REGULAR MEETING AGENDA

**Preliminary Site Plan and Special Use Review
For
Ypsilanti Township, Michigan**

Applicant:	Zippy Auto Wash / Corey Weaver
Project Name:	Zippy Car Wash
Plan Date:	June 2, 2025
Location:	1822 W. Michigan Ave. (W. Michigan Ave. and Ellsworth intersection)
Zoning:	RC, Regional Corridor – Form Based District
Action Requested:	Preliminary Site Plan and Special Use Approval

RE: Zippy
Preliminary Site Plan Review #1

SHEET NO.

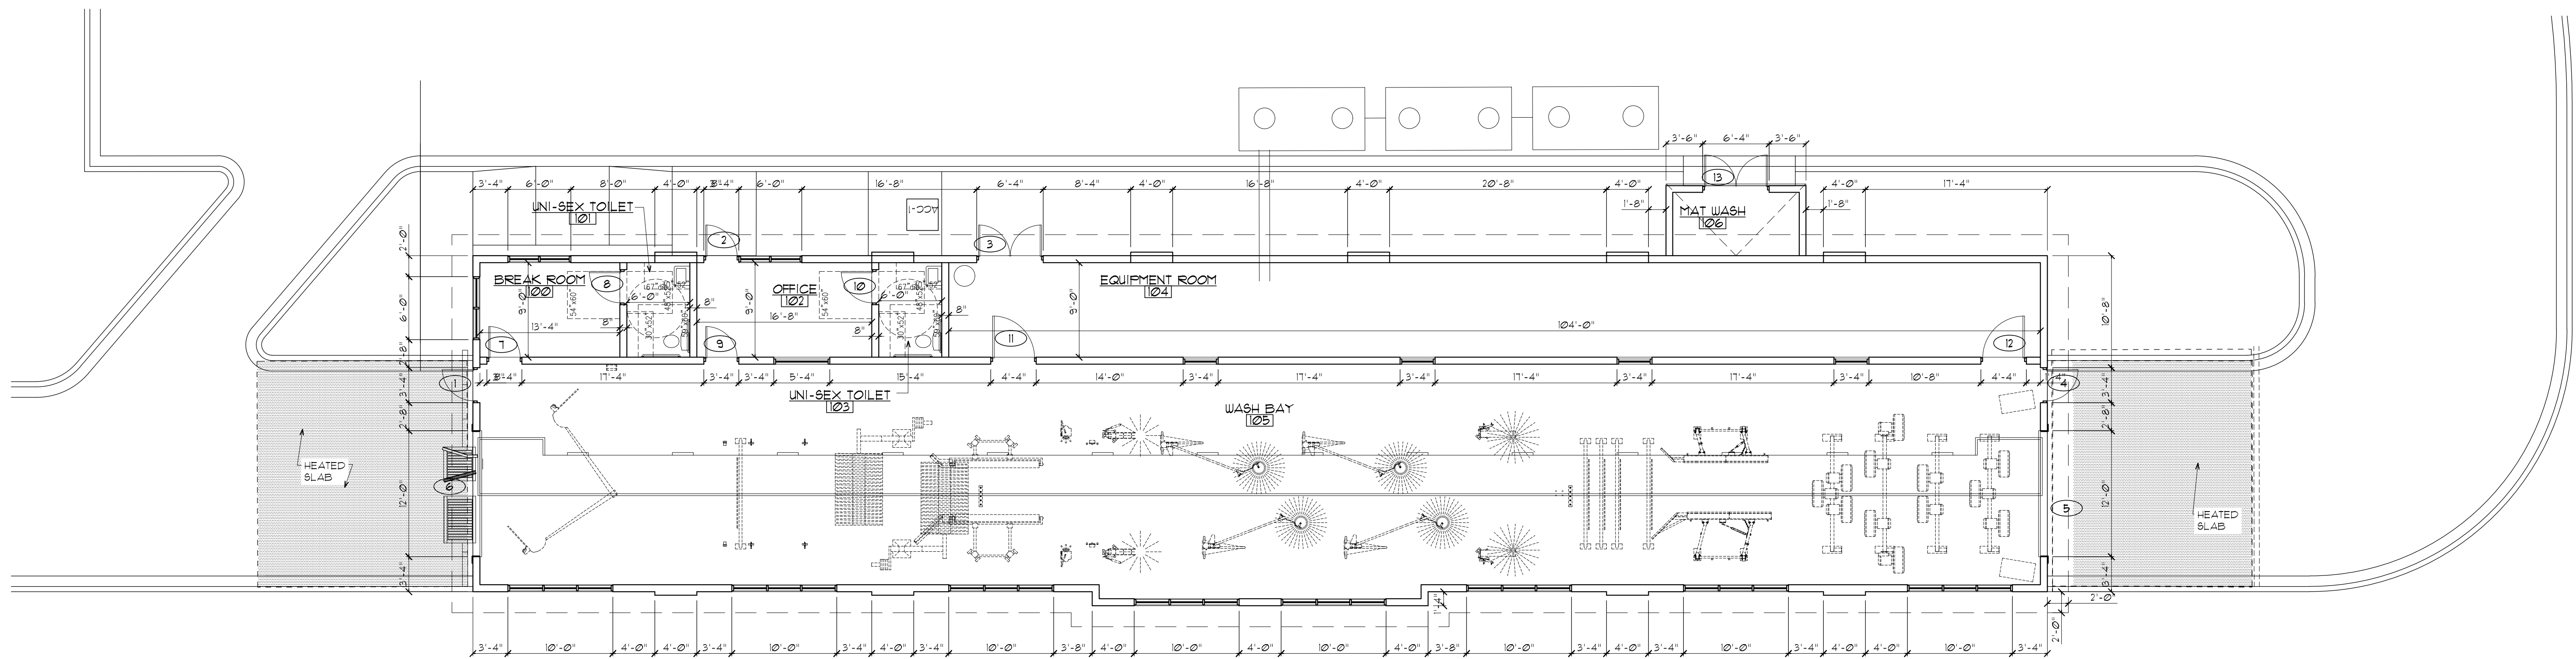
4. The applicant shall review and revise the outlet orifice calculations as it currently appears the minimum time of detention for the first flush storm (24 hours) was not met. The applicant shall update all subsequent calculations accordingly.

8. The applicant shall include the heated slab with the trench drain within the maintenance schedule(s). The applicant shall also remove the wetlands and other components from the maintenance schedule(s) that are not present on-site for clarity.

9. The applicant shall note that storm sewer pipe shall be RCP C-76, per Township Standards, or the load carrying design analysis for use of other materials for the proposed depth conditions shall be provided on the plans.

WEST ELEVATION

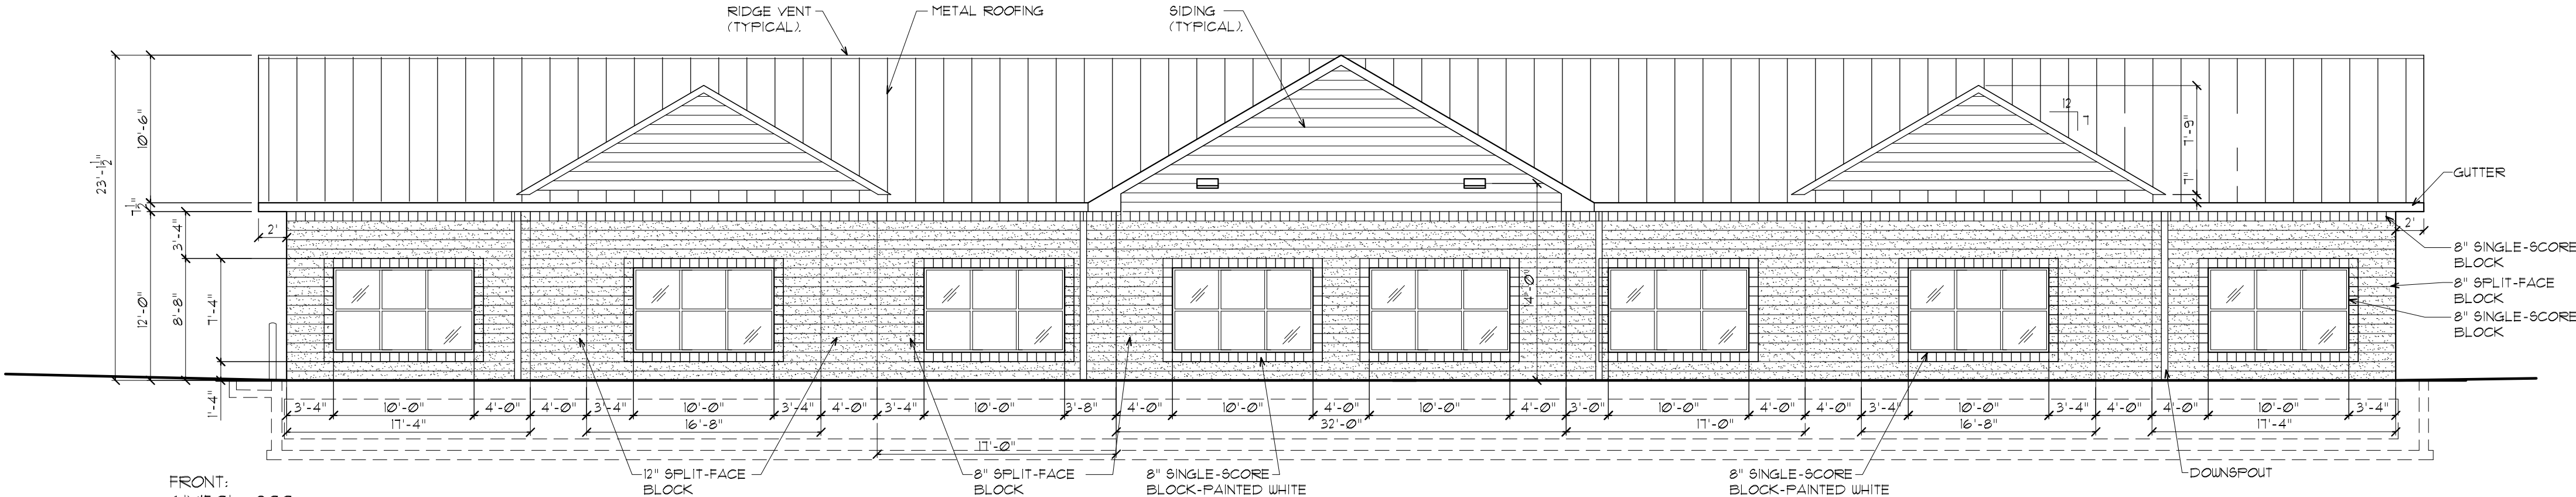
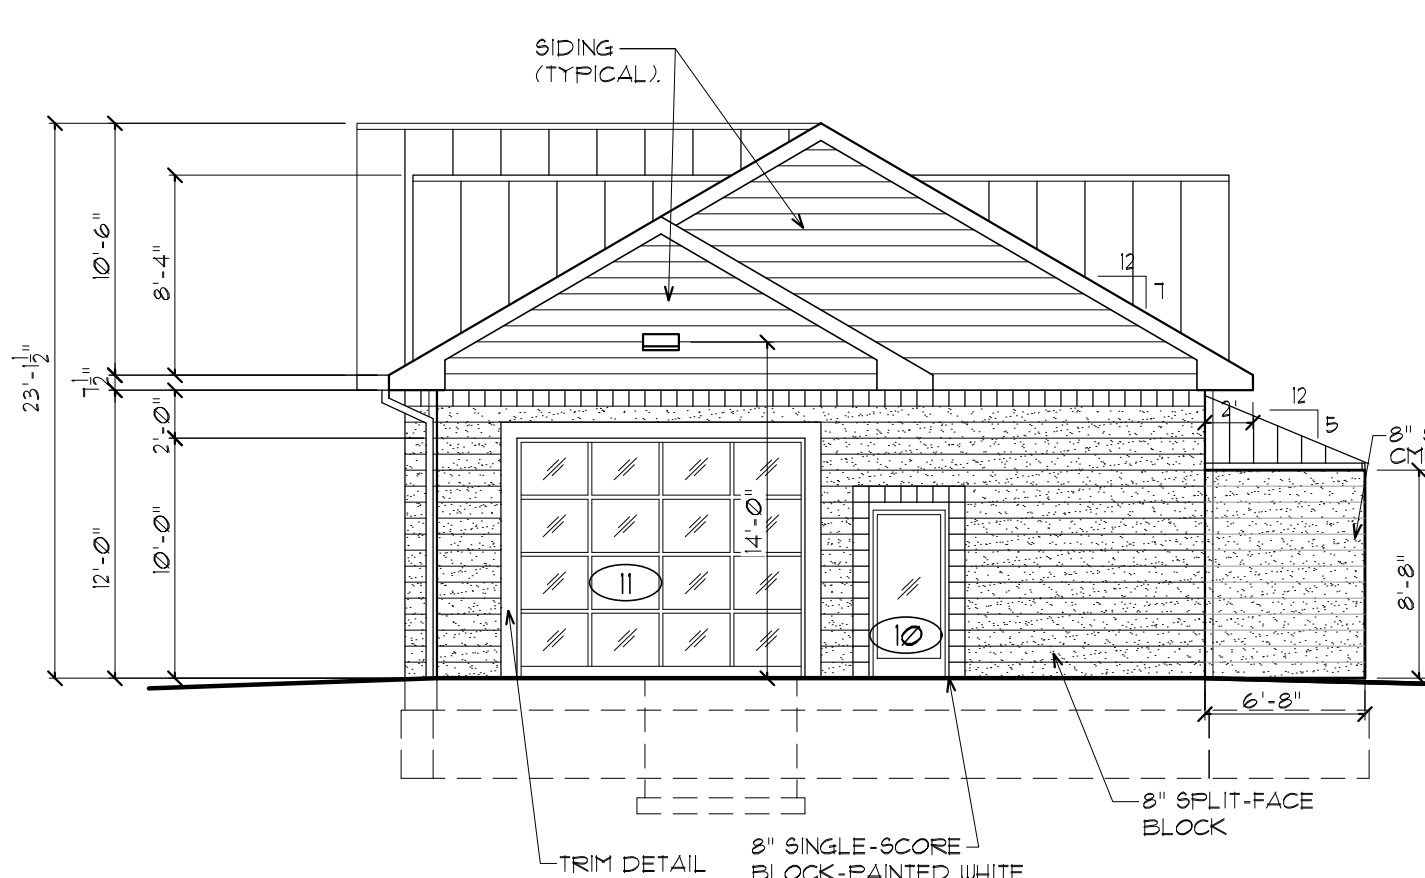
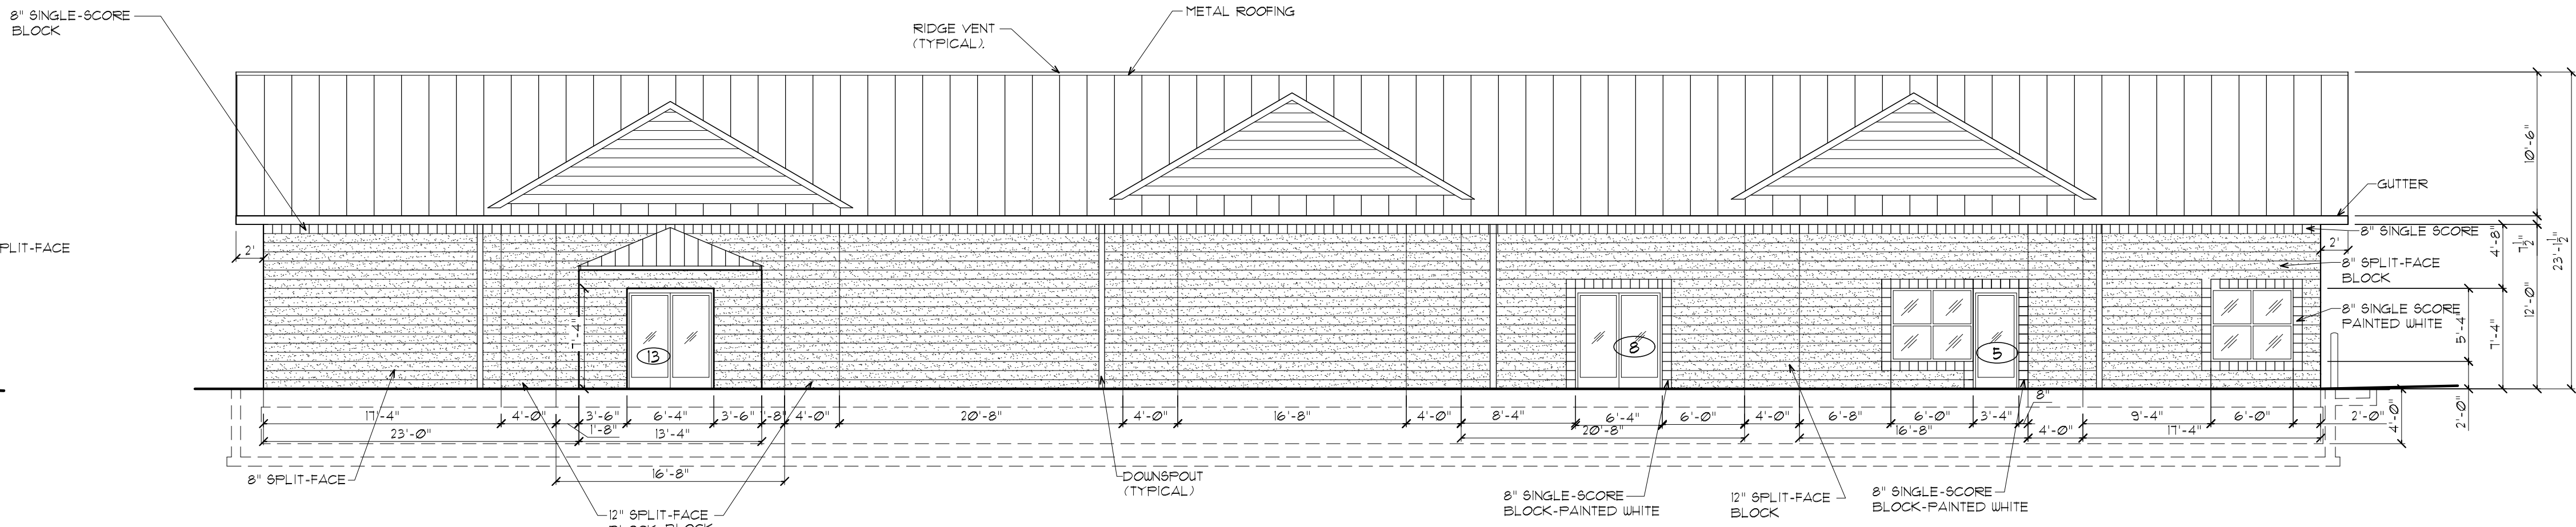
First floors facades facing a right-of-way are required to provide 50% transparency. First floor facades facing a parking area are required to provide 30% transparency. Transparency calculations have not been provided. We have scaled the plans to evaluate how the building design meets these standards. A transparency calculation should be provided for the north and south elevations.

- The plans should specify that the windows are transparent, and not tinted, reflective or opaque glass (which is prohibited).

Items to be Addressed: 1) Plans to specify the type of siding to confirm that high-quality materials are being used. 2) Add transparency calculations for north and south facades to Architectural Plans. 3) Planning Commission to consider counting the picnic table along sidewalk short-cut between the W. Michigan safety path and the Ellsworth Rd. safety path for the deficient transparency on the north side of the building. 4) Specify on Architectural Plans that windows and doors are transparent (and not tinted, reflective or opaque glass).

- 1) *Specify the type of siding on Architectural Plans to confirm that high-quality materials are being used.*
- 2) *Add transparency calculations for north and south facades to Architectural Plans.*
- 3) *Specify on Architectural Plans that windows and doors are transparent (and not tinted, reflective or opaque glass).*
